**SECTION 00 90 01  
BIDDING AND CONTRACT REQUIREMENTS  
ADDENDUM NUMBER (6)**

Issued: May 3<sup>rd</sup>, 2024

**Re: ADDENDUM NUMBER (6) TO THE BIDDING DOCUMENTS FOR**

**Peoria Park District  
Golf Entertainment Facility Renovation an Addition  
Architect's Project Number: 22-051**

SHEET NUMBER:  
**E1.22**

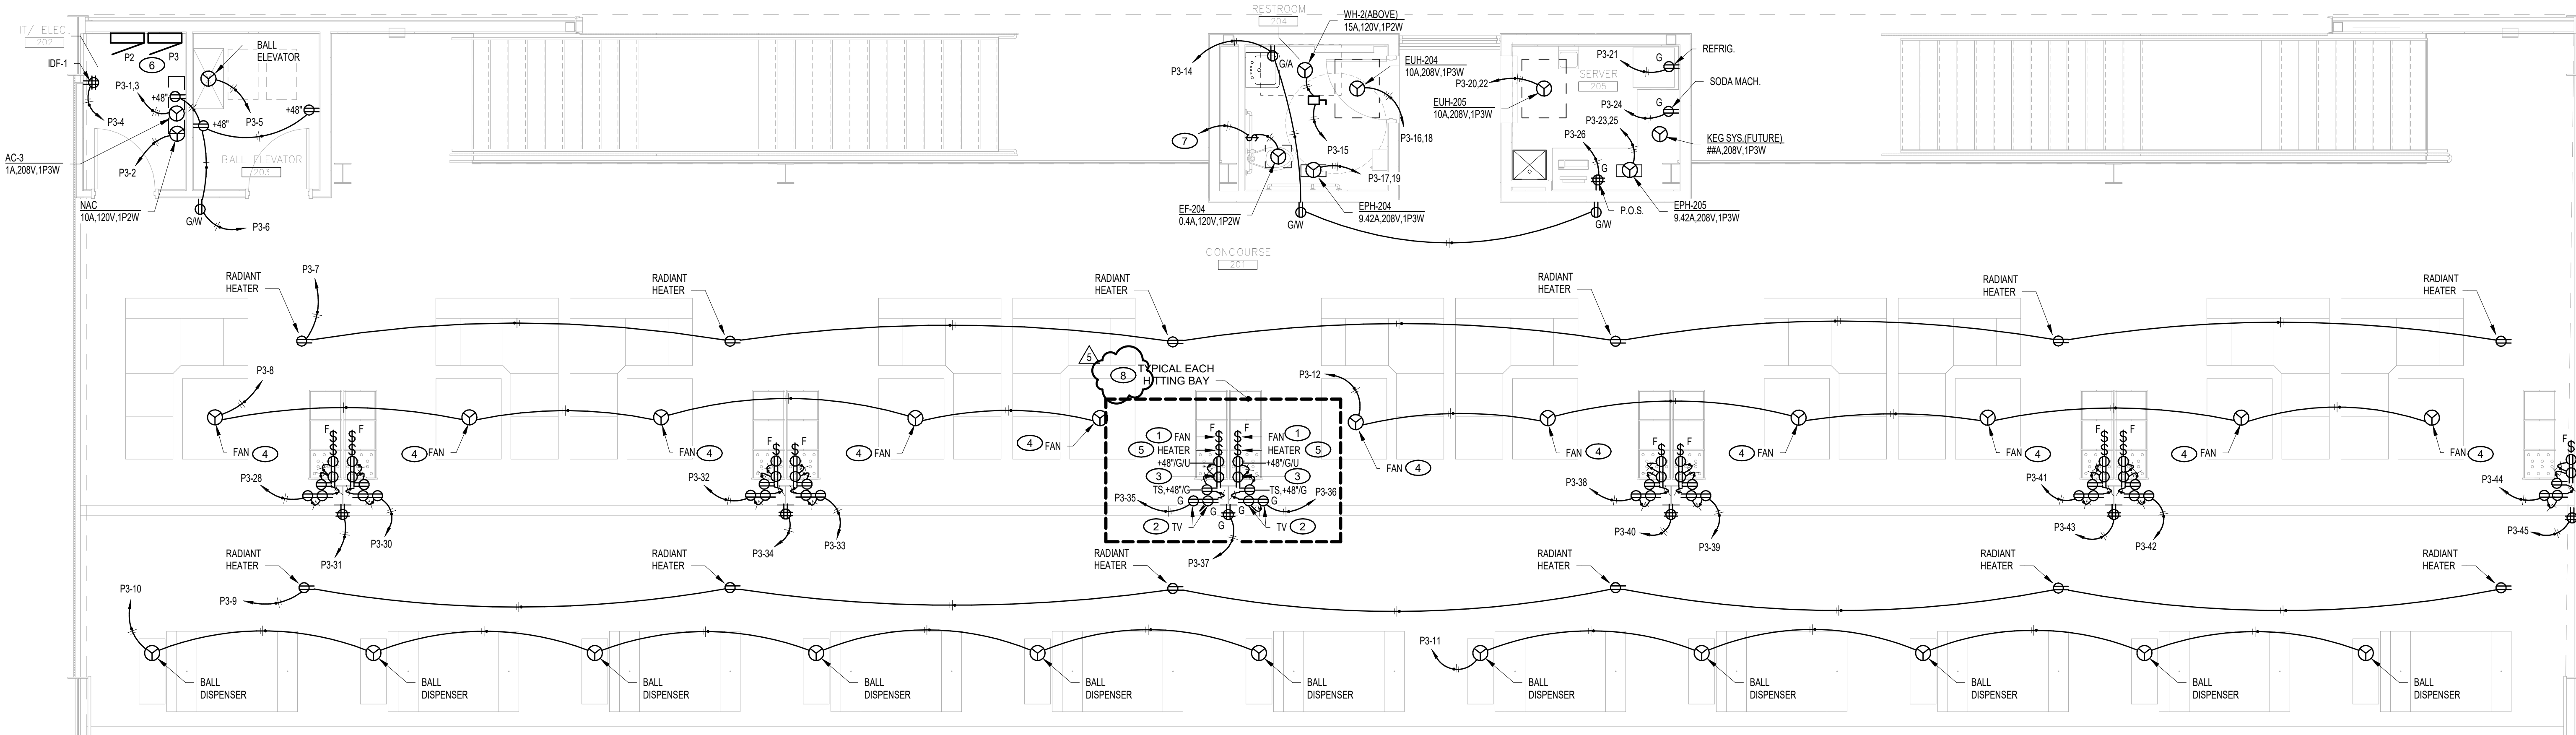
4. E1.22 – SECOND FLOOR PLAN – RANGE BAYS – POWER
  - a. Added keyed note #7 clarifying typical bay receptacle and installation requirements.
5. E1.23 – SECOND FLOOR PLAN – RANGE BAYS – SYSTEMS

***E1.22 EF-204 is showing its .4A but on the E2.0 Equip. Connections Schedule it shows 60A and #4 wire. This is also the same for EF-113 on E1.12. Those EF should not have been on the schedule. They are to be circuited with the lighting circuit and controls serving the restrooms. See keyed note #6 on E1.12 and #7 on E1.22.***

SHEET NUMBER:  
**E1.23**

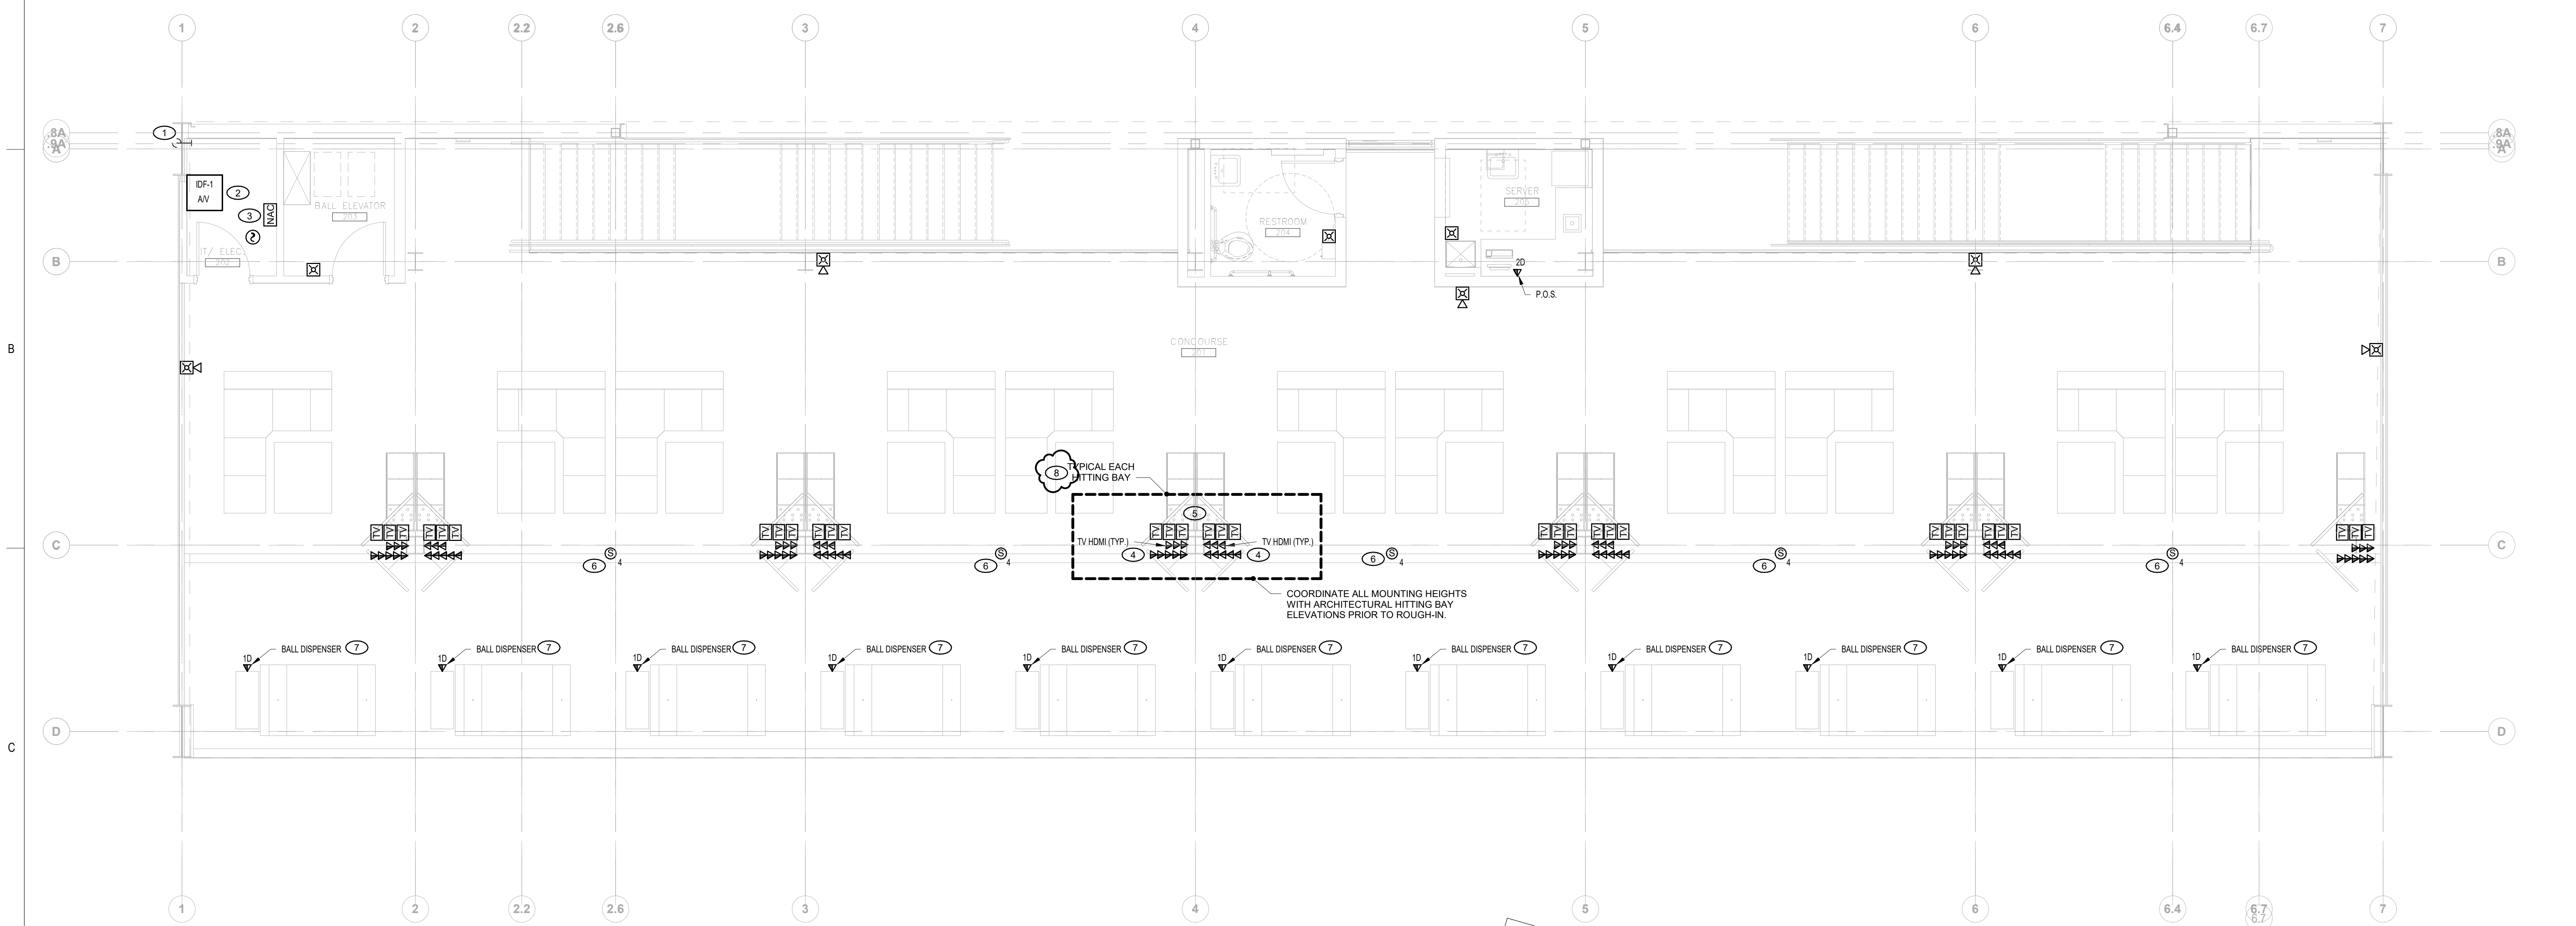
- a. Revise keyed note #4 for clarification of data cabling and rough-in installation at each bay.
  - b. Revise keyed note #5 to provide separate conduit runs for each bay mounted TV back to IDF-1.

- c. Added keyed note #8 clarifying typical bay cabling and installation requirements.
6. E4.1 – TELECOMM. RISER, SCHEDULE, AND NOTES
  - a. Revise Telephone and Data Equipment Schedule to redefine and clarify scope and division of labor of IT and A/V installations as follows:

SHEET TITLE:  
**TELECOMM. RISER, SCHEDULE, AND NOTES**

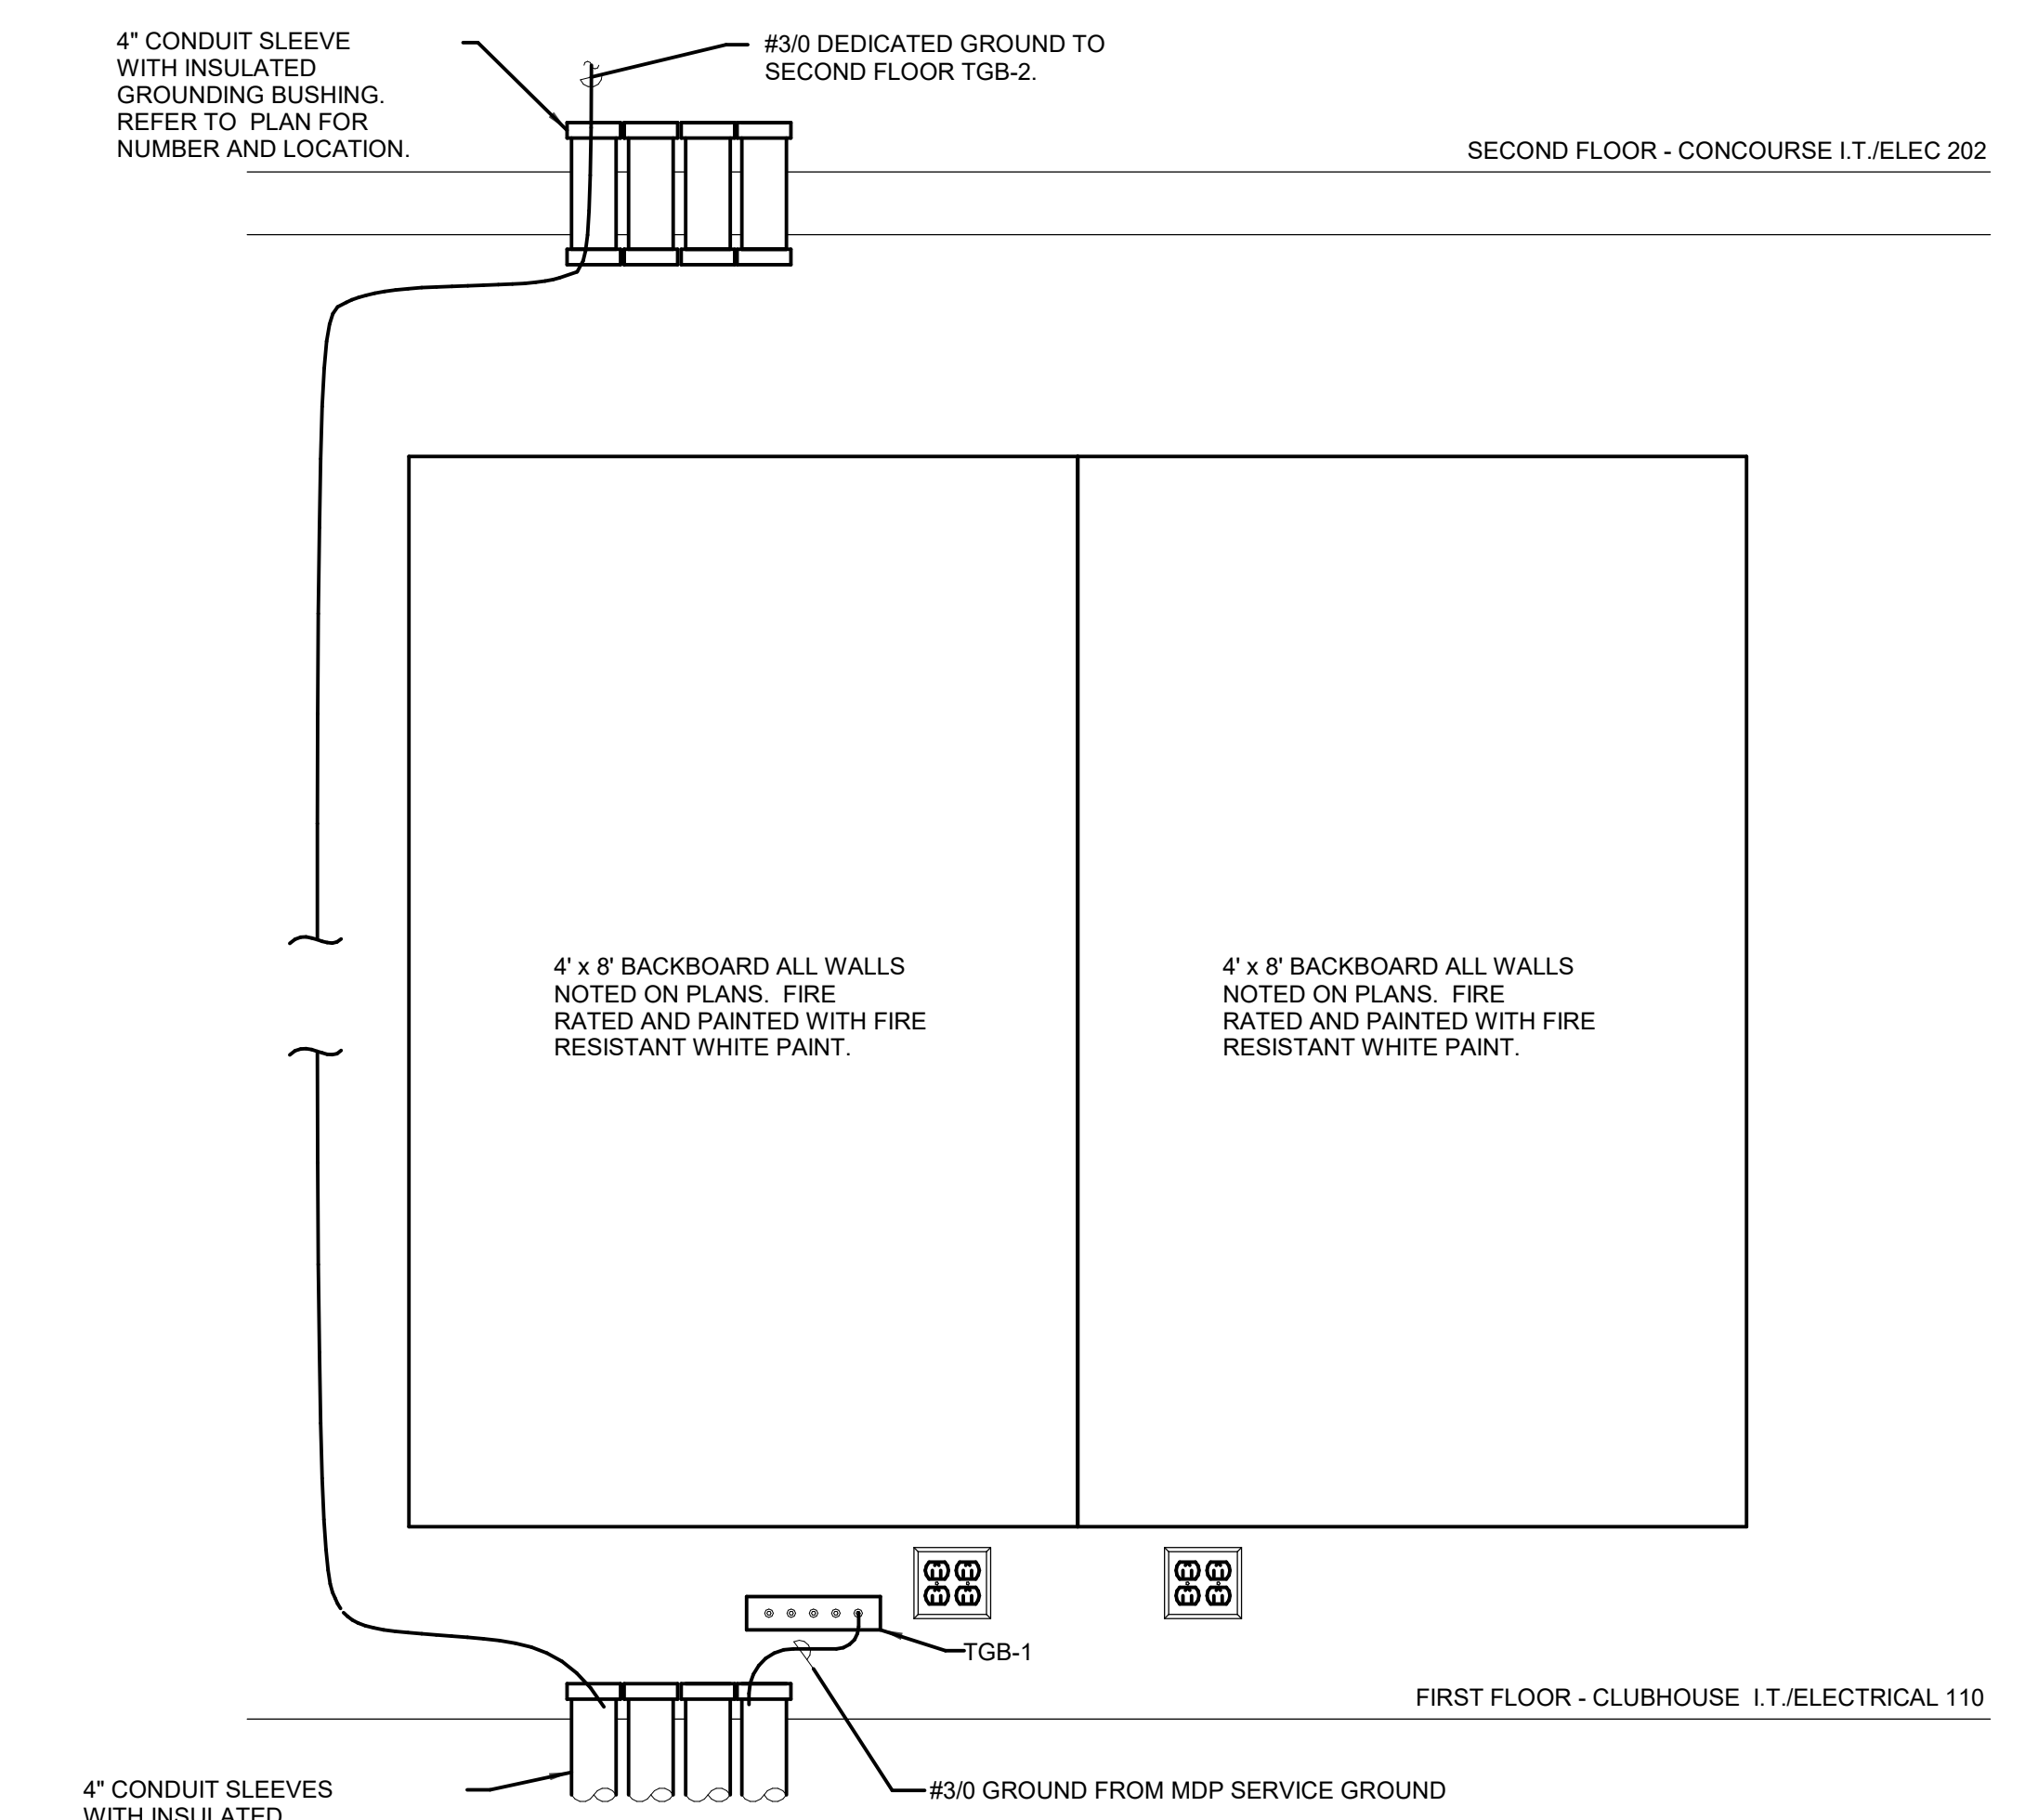
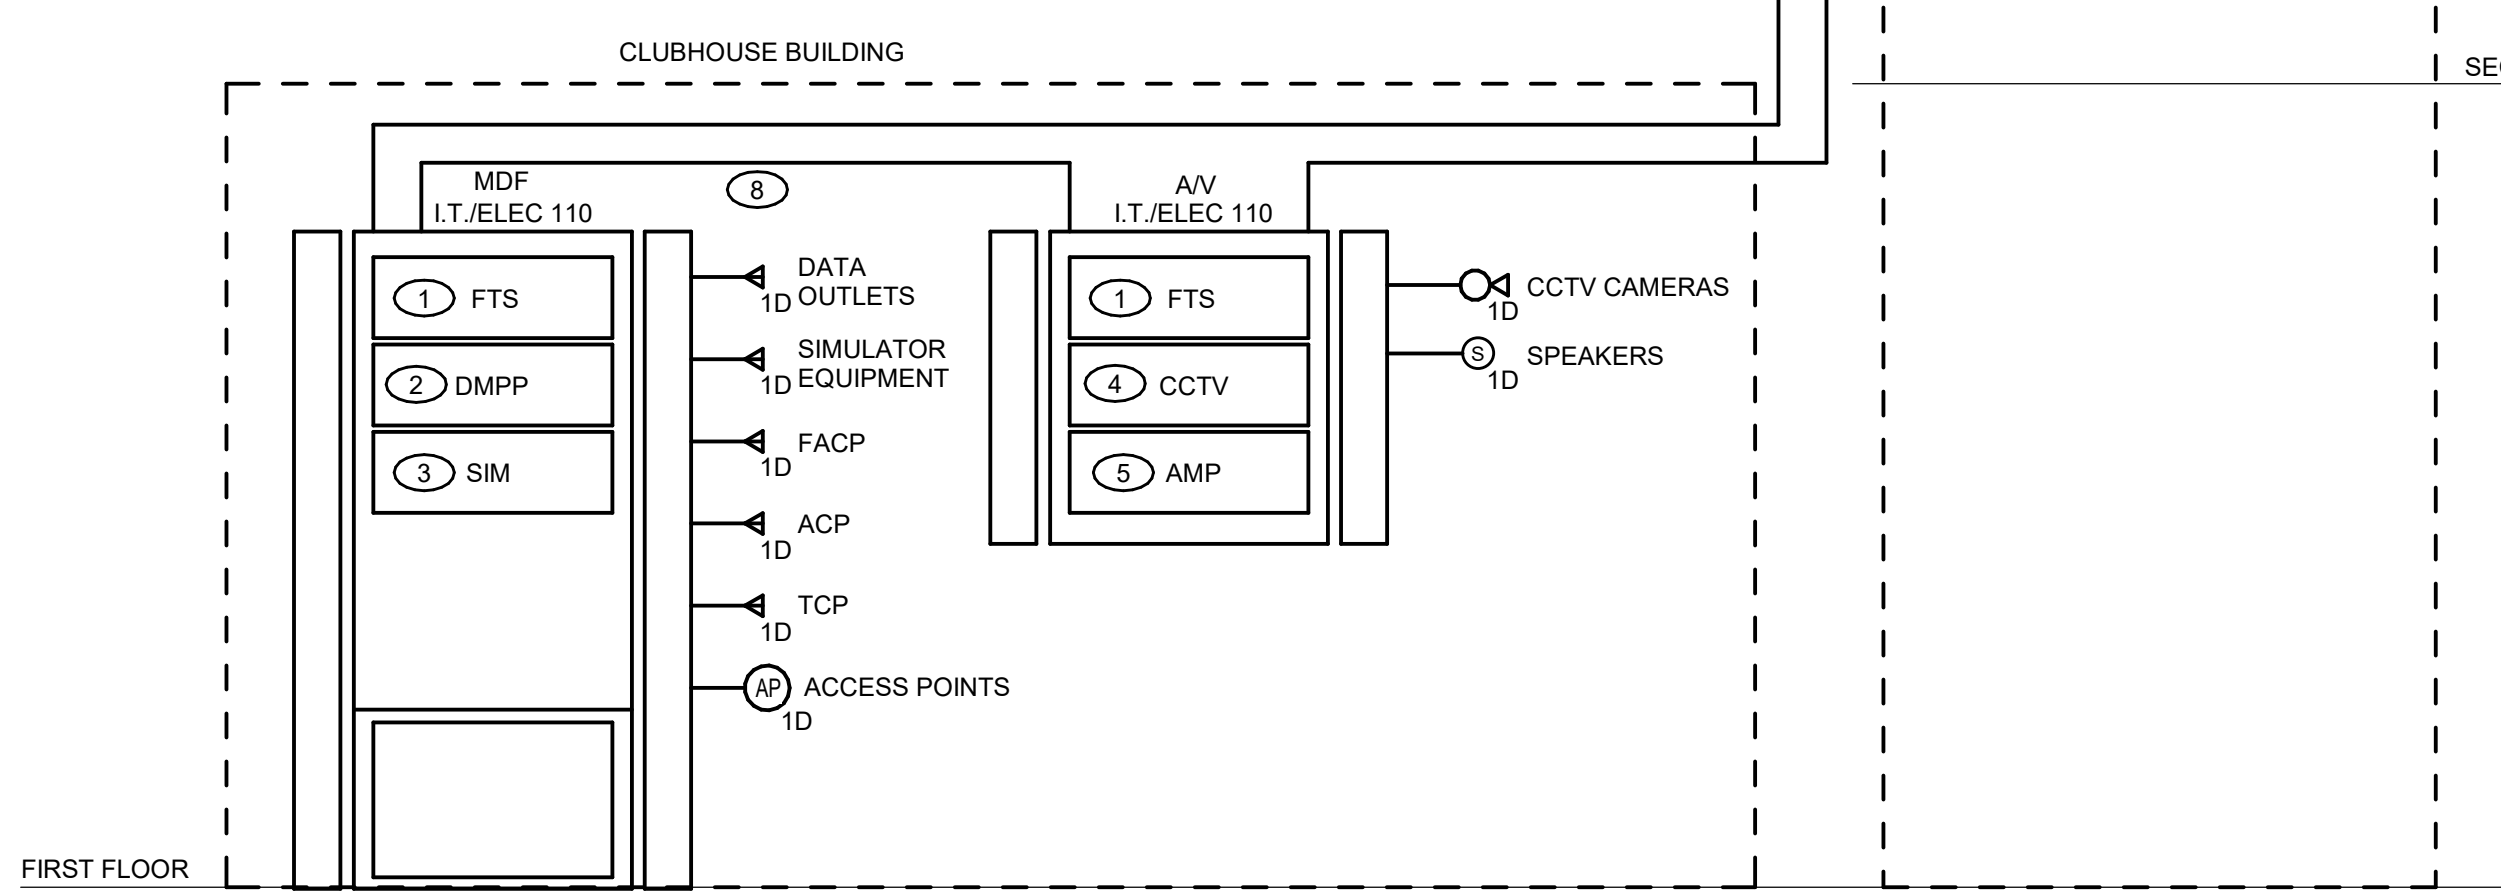
- 1) IT:
      - (a) Equipment – Furnished by owner; Installed by certified system installer.
      - (b) Cabling – Furnished, installed, and tested by certified system installer.

- (c) Terminations – By EC.
    - 2) A/V:
      - (a) Equipment – Furnished and installed by owner.
      - (b) Cabling – Furnished and installed by certified system installer.

- (c) Terminations – By EC
    - 3) All rough-in of conduit and back boxes by EC for all IT and A/V installations.

E1.0 Note 3 says to route 4 – 3" empty conduits for telecom. It notes that one of those is for the panel feed, but that won't be empty. E4.1 Detail 1 note 7 says 3 – 3". There is also an unnumbered note on Detail 1 saying to provide 2 – empty 3". E1.03 Notes 8 (MDF – 2 conduit) and 14 (FACP – 1 conduit) total 3 – 3". The different notes seem a little confusing and that they're not totally saying the same thing if they can be reviewed.

**E4.1 Equipment Schedule Item 3 notes "OSF Standards". I know it will get brought up by the data people since this isn't an OSF job, so I wanted to bring it up now so there's no confusion about special standards they have to meet. **My apologies, I must have missed that when I revised the rest of it. See revised electrical drawings .****

E4.1 Item #3 – I had asked a question about the Systimax cabling "owner approved" installer and it appears it was reworded to open it to all installers and that we are to include cabling in our bid, however now it says that the "owners A/V rep shall provide all equipment and labor" and that we are to include that cost in our bid. If we are to include that cost in our bid, we need to know who this A/V rep is so we can contact them. **I received further clarification from the owners on this, their in-house A/V team will furnish and install all A/V equipment and devices. E.C. shall provide rough-in of back boxes and conduits and pull cabling for all devices. All coordination will be through the park district.**

My apologies, I could see how that is confusing. To sum it up, we will need 4 total 3" conduit from the elec/it room in the main building to the elec/it room(s) in the hitting bays. One conduit shall be for feeders to the panels. Two conduits shall be used for fiber and telecommunications from MDF to the IDF. One conduit for fire alarm from FACP to the local panel in the new building. The only conduit the E.C. is responsible for pulling the cabling through is the power feeder conductors for the panels. The owners IT installer and other vendors will pull their cabling for fiber, telecom, and FA.
